REMARKS

AMENDMENTS TO THE DRAWINGS

Application S/N: 10/699,779 Docket No. P03344-USDIV

FIG. 29

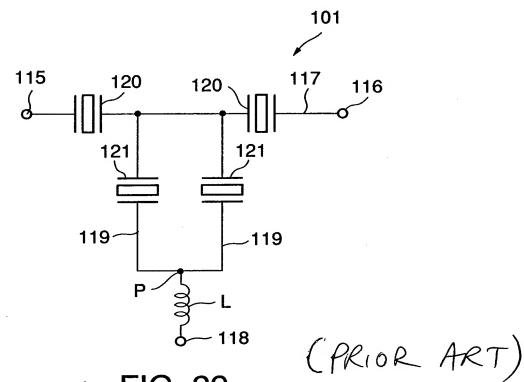
The attached drawing sheet includes a change to Figures 29-35 to add the "Prior Art" label, as requested by the Examiner.

The Examiner has objected to Figures 29-35 for failing to include a "Prior Art" label.

Applicant includes a drawing revision identified above to address this concern.
